Access Compliance Report

Public Rights-of-Way

Intersection ID: 28446	Main Street: SHINING_OAK_LN	Cross Street: SUMMER_CREEK_LN	Location: SW
ADA ID: 9A13E3B30EC1	Ramp Type: BlendTrans2	Initial Pass/Fail: Fail	Overall Compliance: No
		Severity Score: 25

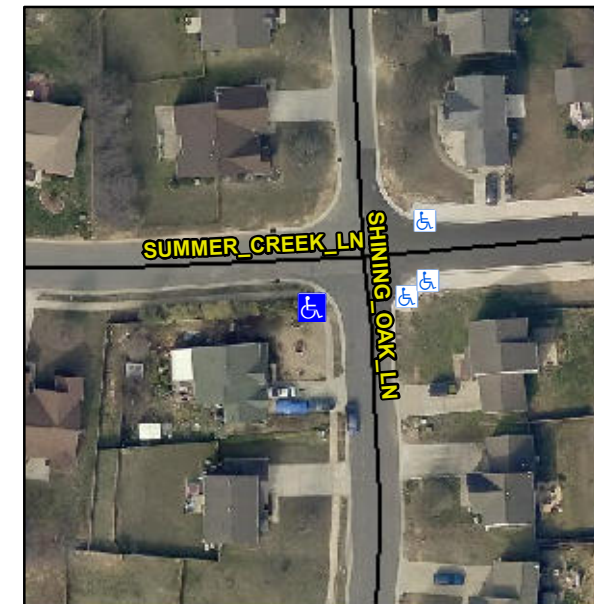
Not Found, R304.5.3

Compliance	Description	Data	Compliance	Description	Data
N/A	Ramp Length (in)	95.0	Yes	BlendTrans Slope (%)	4.6
Yes	Ramp Width (in)	48.0	No	BlendTrans XSlope (%)	8.5
N/A	Flare Type LT	N/A	N/A	Flare Type RT	N/A
N/A	Flare Slope LT (%)	N/A	N/A	Flare Slope RT (%)	N/A
N/A	Flare Traversable LT?	N/A	N/A	Flare Traversable RT?	N/A
N/A	Landing Length (in)	N/A	N/A	DWS Provided?	N/A
N/A	Landing Width (in)	N/A	N/A	DWS Contrast?	N/A
N/A	Landing Slope (%)	N/A	N/A	DWS Length (in)	N/A
N/A	Landing X Slope (%)	N/A	N/A	DWS Full Width?	N/A
N/A	Landing Curb? (Y/N)	N/A	N/A	DWS Offset (in)	N/A
N/A	Shared Landing?	N/A			
N/A	Gutter Ponding?	N/A	N/A	Gutter Slope (%)	N/A
N/A	Gutter Lip Ht (in)	N/A	N/A	Gutter X Slope (%)	N/A
N/A	Painted X Walk1?	No	N/A	Painted X Walk2?	N/A
	X Walk 1 Direction	To E		X Walk 2 Direction	N/A
	X Walk 1 Width (in)	N/A		X Walk 2 Width (in)	N/A
	X Walk 1 Slope (%)	4.0		X Walk 2 Slope (%)	N/A
	X Walk 1 X Slope (%)	4.6		X Walk 2 X Slope (%)	N/A

Remove & Replace Curb Ramp With Two New Directional Ramps or Equivalent.
